**Subject: Bingham Wind Project, Summary of Spring Salamander Surveys and Proposed Habitat Management
Project # L-25973-24-A-N / L-25973-TG-B-N**

Subject: Bingham Wind Project, Response to Preliminary Review Comments from MDIFW Fisheries Division

BIGELOW BROOK

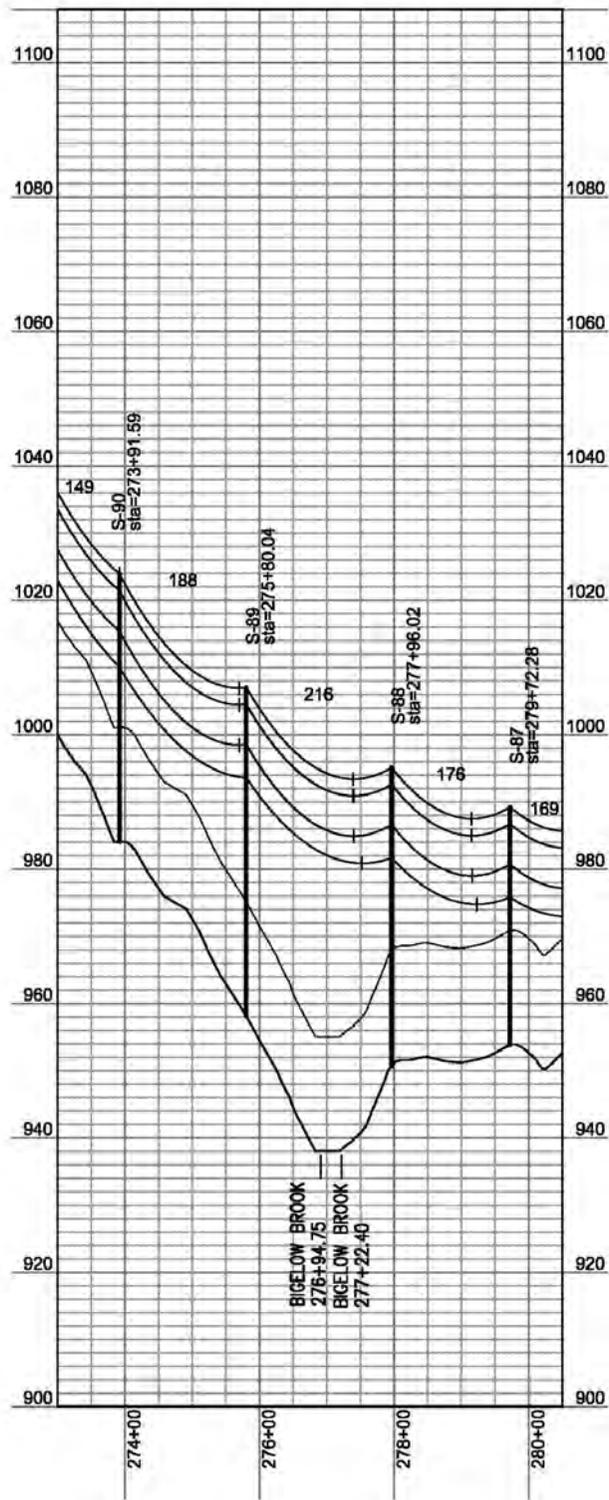
Bigelow Brook — The collector line will cross Bigelow Brook approximately 185 feet northwest of the Route 16 crossing. A steep bank on the west side of the stream should help increase conductor height over the stream and reduce the number of trees that will need to be topped.

BEAR BROOK

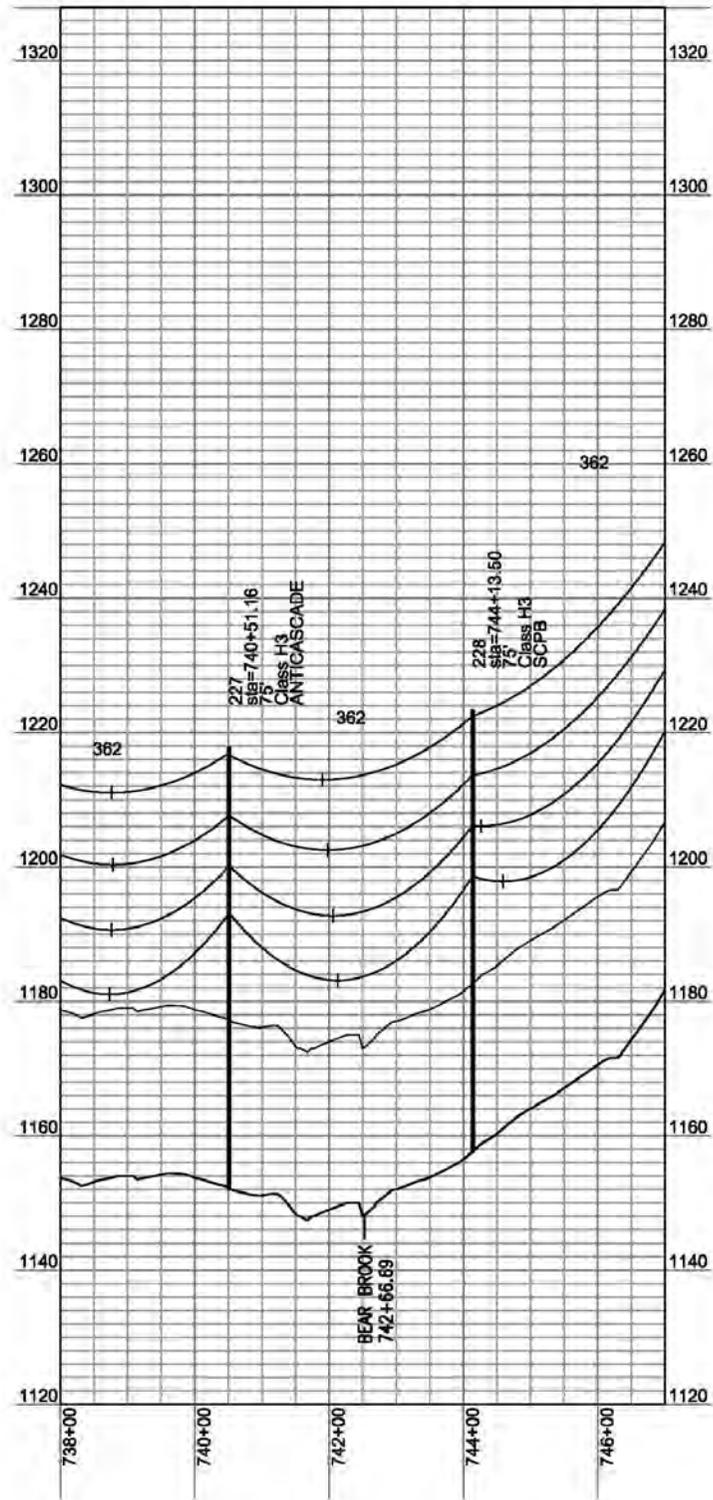
Bear Brook — Bear Brook is situated in a small valley and bordered by upland forest. The surrounding forest is several feet higher than the stream and should help increase conductor height over the stream and reduce the number of trees that will need to be topped. Further, the narrow width of Bear Brook in this area will allow for the development of a dense streamside shrub community. These shrubs will provide the stream channel itself with canopy cover, limiting or mitigating any potential warming concerns.

BOTTLE BROOK

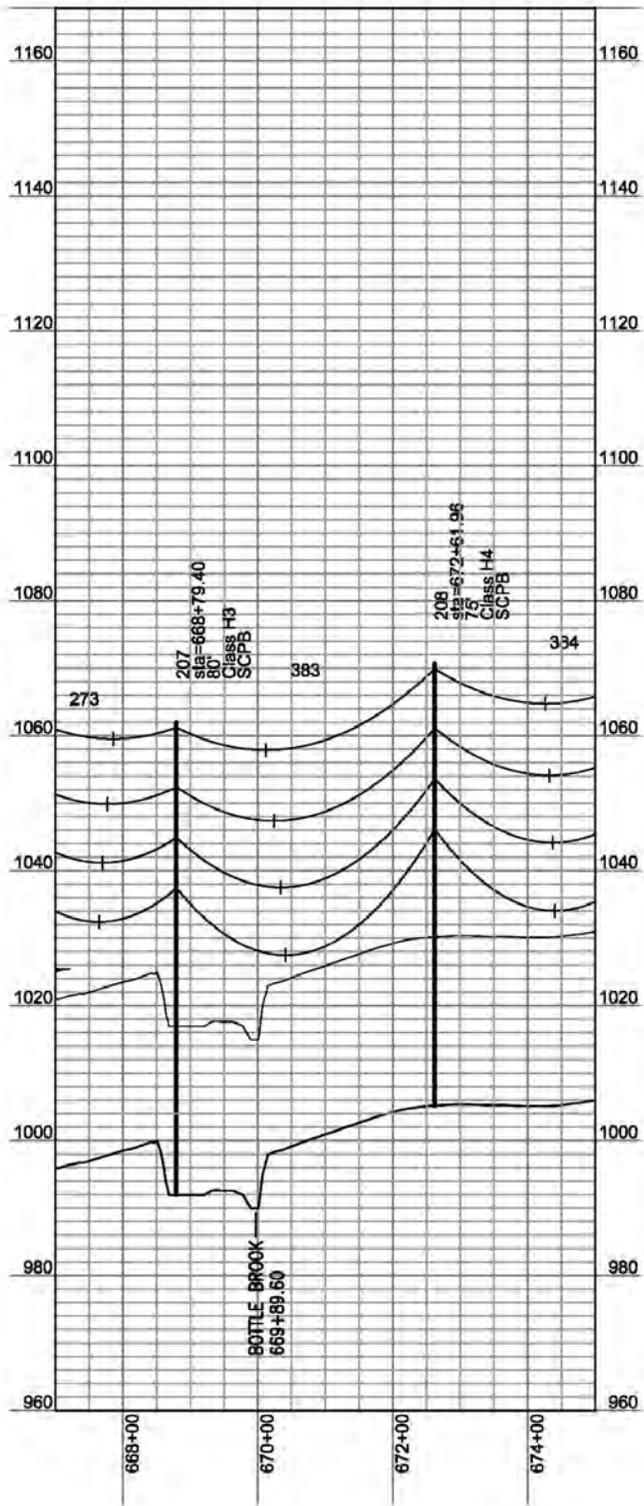
Bottle Brook — Bottle Brook is situated in a small valley. A steep slope leads down to the stream from the west. This slope should help increase conductor height over the stream and reduce the number of trees that will need to be topped. Timber harvesting operations occurred within the last 3-4 years on the east side of the stream. Disturbance and tree removal extends to within approximately 25-35 feet of the stream bank. A limited number of trees remain on the east bank that will need to be topped. Vegetation maintenance at this crossing will allow for the reestablishment of dense shrubs and saplings along the banks of this narrow brook, particularly along the previously impacted eastern bank. This shrub and sapling development will provide shading to the already exposed stream channel.

KINGSBURY STREAM

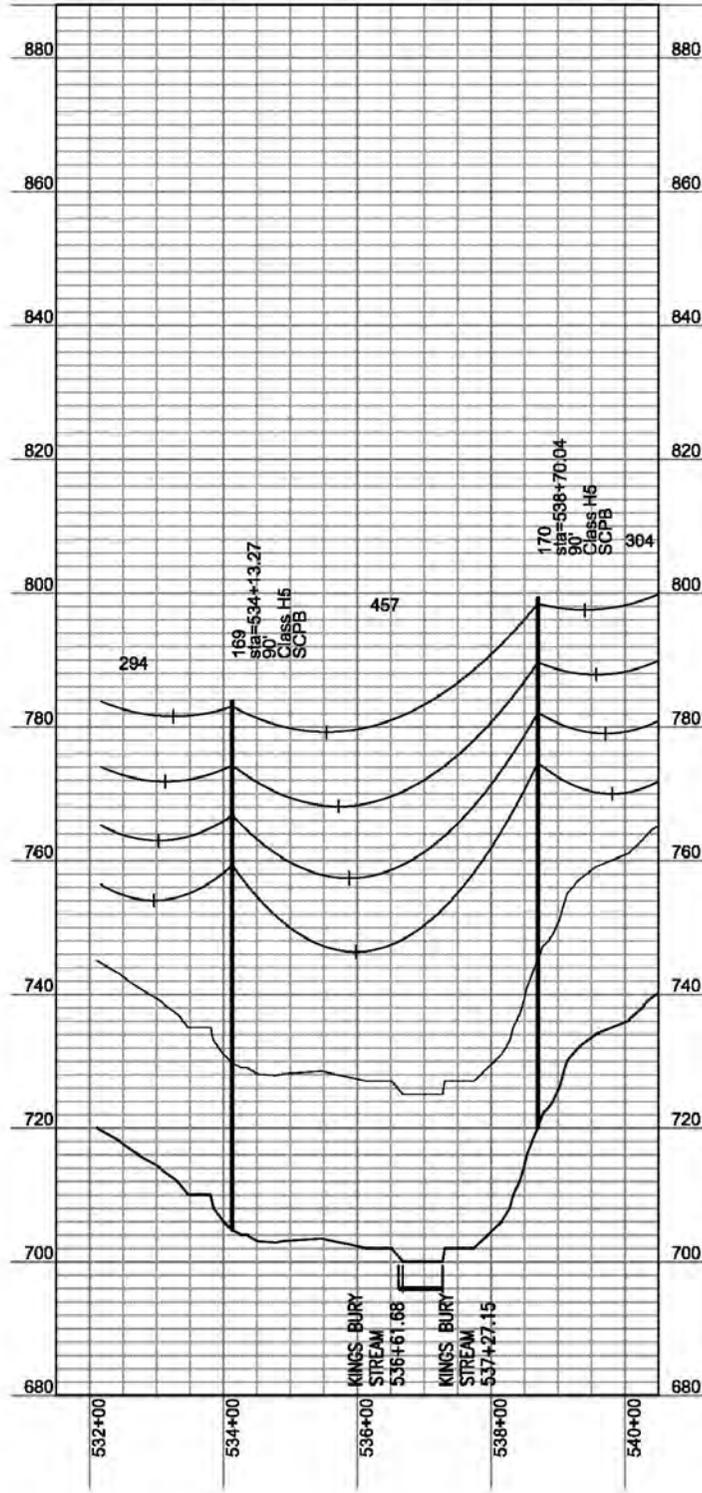
Kingsbury Stream — The generator lead will cross Kingsbury Stream adjacent to an existing bridge. Current conditions in this area provide little shading of the stream. It is likely that topping trees within 100 feet of the Kingsbury Stream will not result in adverse impacts to the stream. While some trees currently providing some shade to the channel will be removed, the width of the stream already creates a high degree of sun exposure.
